INVESTIGATION OF AN ULTRASONIC INDICATION IN THE
INDIAN POINT UNIT 2 REACTOR PRESSURE VESSEL

Indian Point Unit No. 2

Docket No. 50-247

RESPONSE TO OUTSTANDING QUESTIONS CONTAINED IN
NRC's REQUEST FOR ADDITIONAL INFORMATION DATED AUGUST 16, 1984

IPP-1100A

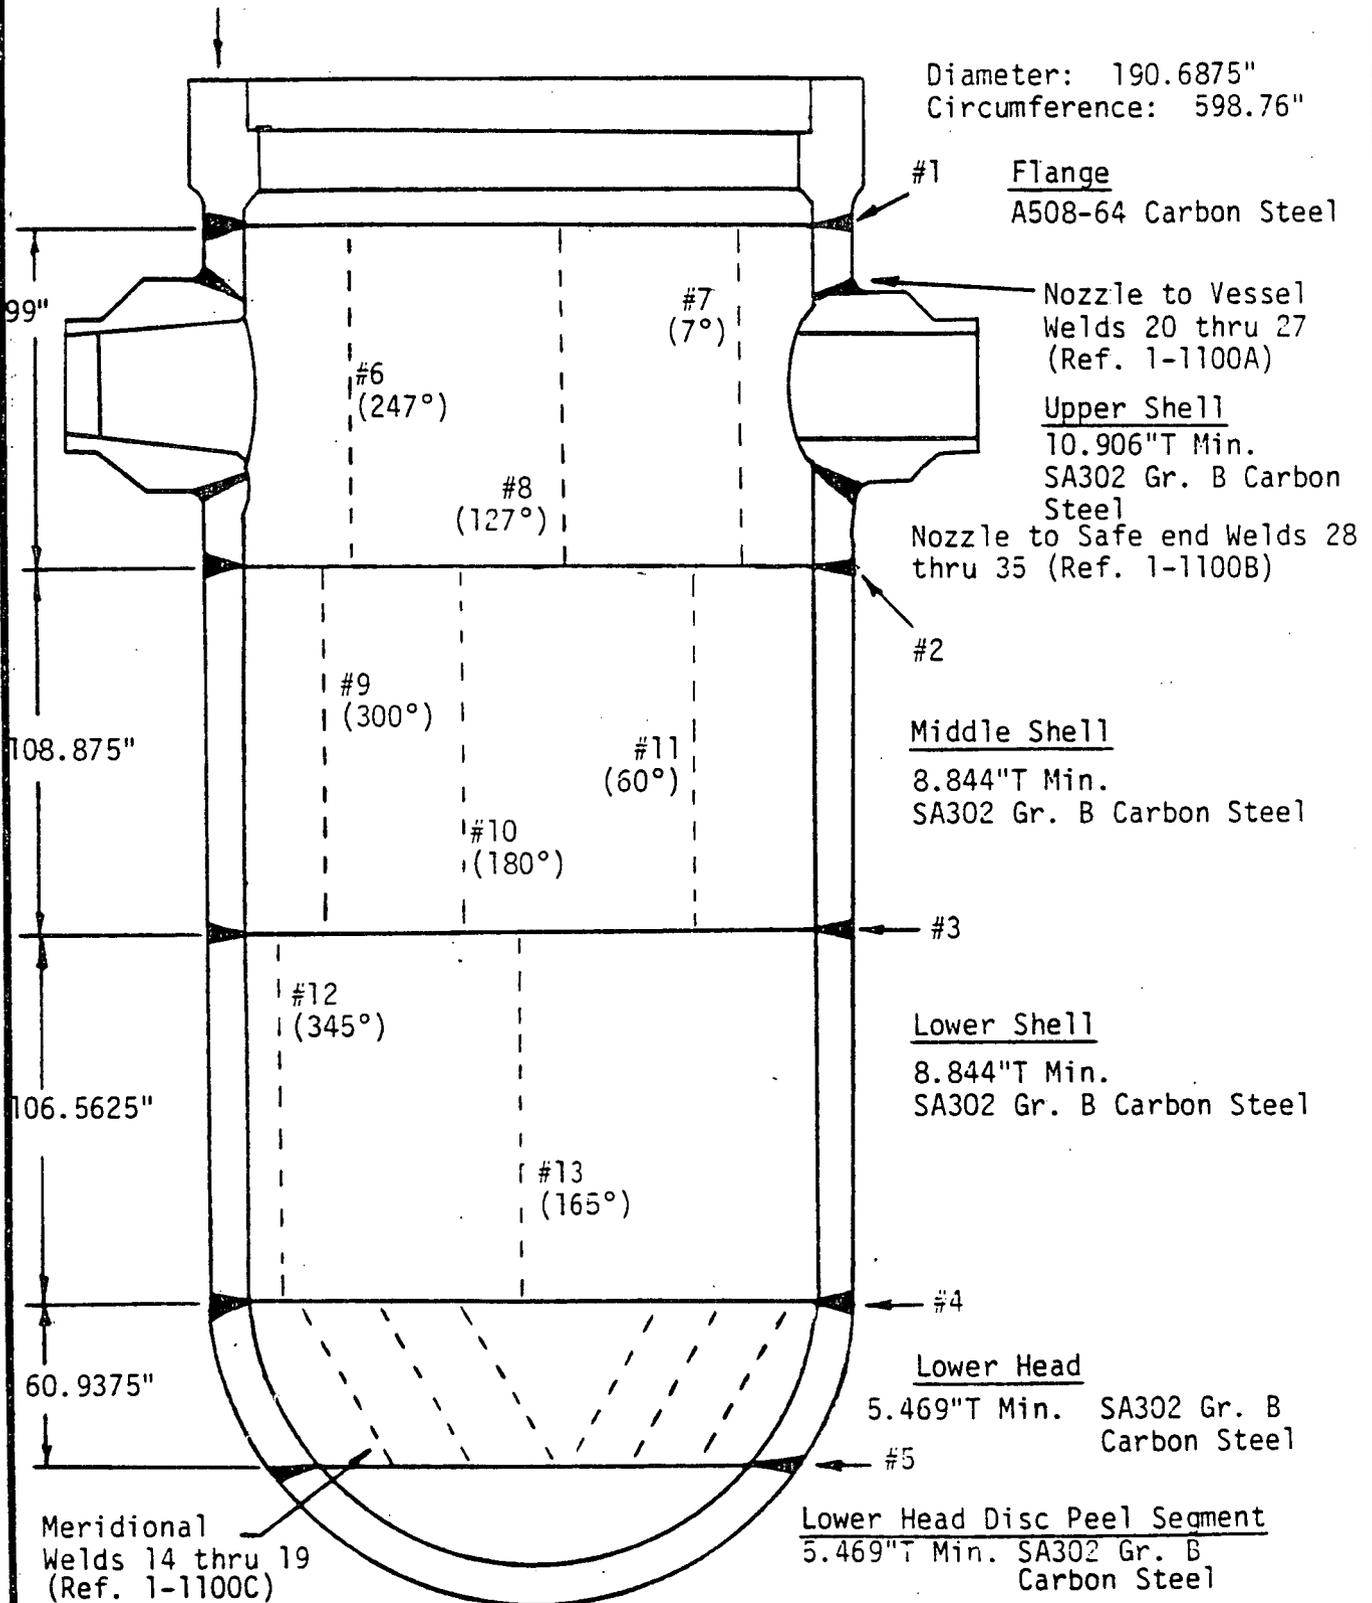
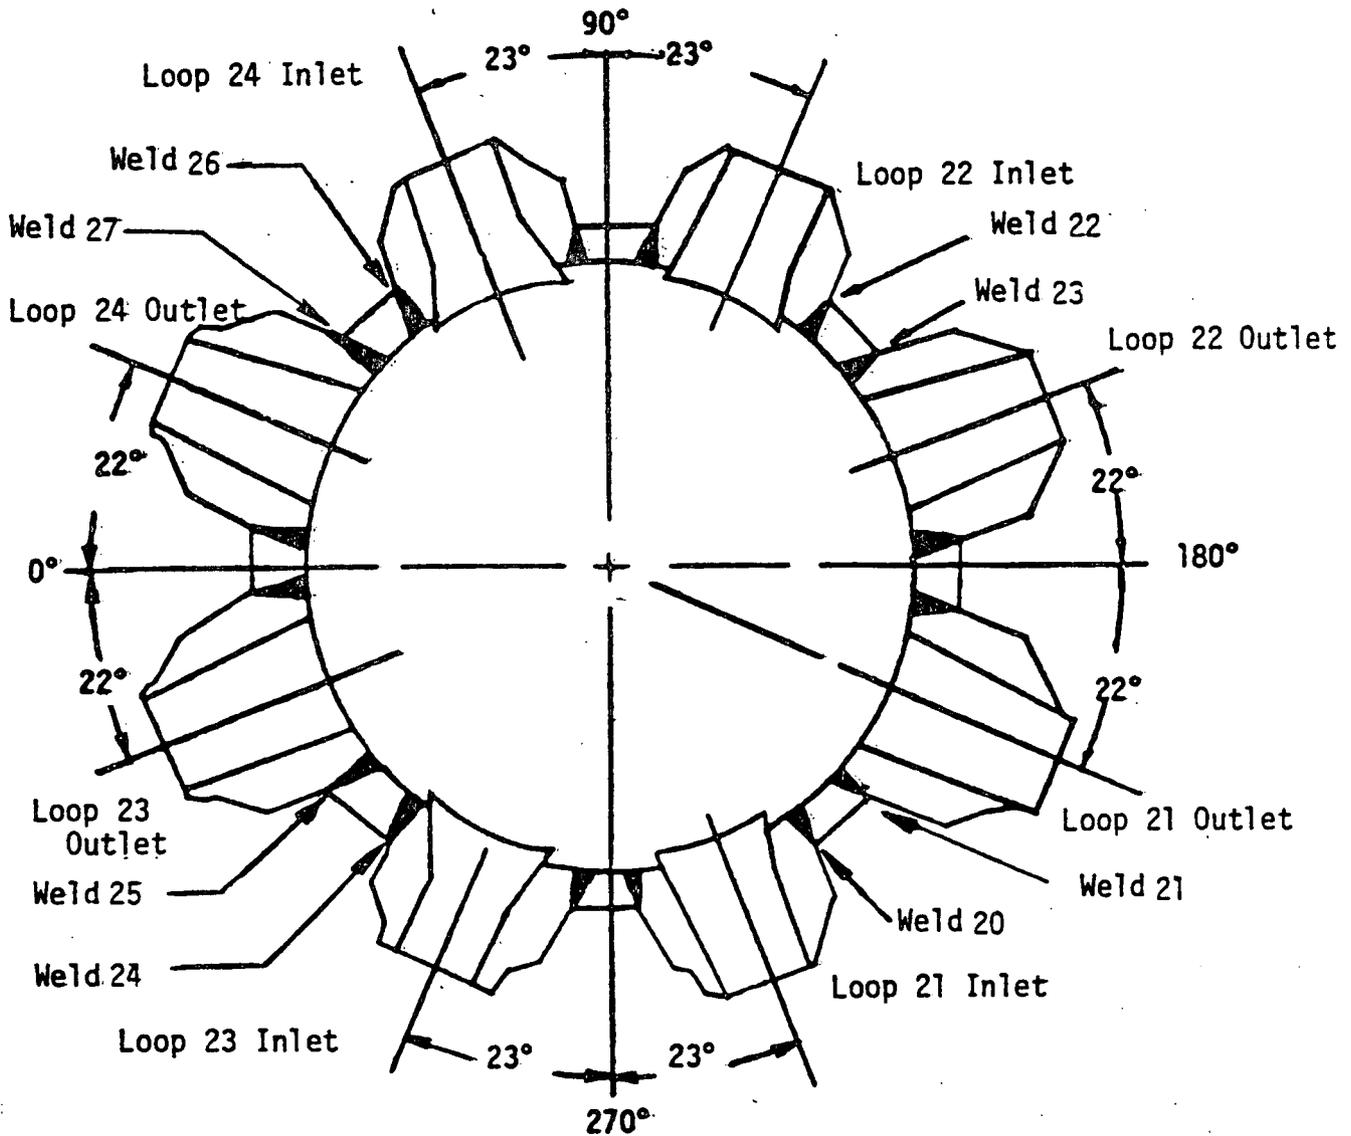
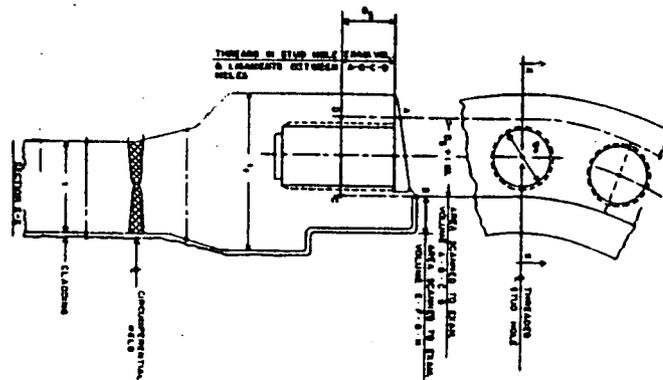
The licensee should provide a summary table defining the location, characteristics, and dimensions of the approximately 49 "relevant" ultrasonic indications.

Attached is Table 1 and Sketches IPP-1-1100 and IPP-1-1100A which together identify the 49 valid (relevant) vessel indications. Forth-eight of the 49 valid indications were evaluated in accordance with ASME Code Section XI criteria and were found acceptable upon initial evaluation. The single reflector identified in welds 3 and 12 required further evaluation to determine its acceptability in accordance with the code and is the subject of the questions and associated responses contained in this report. The dimensions shown in Table 1 for the indication identified in welds 3 and 12 are the final dimensions determined as a result of this investigation.
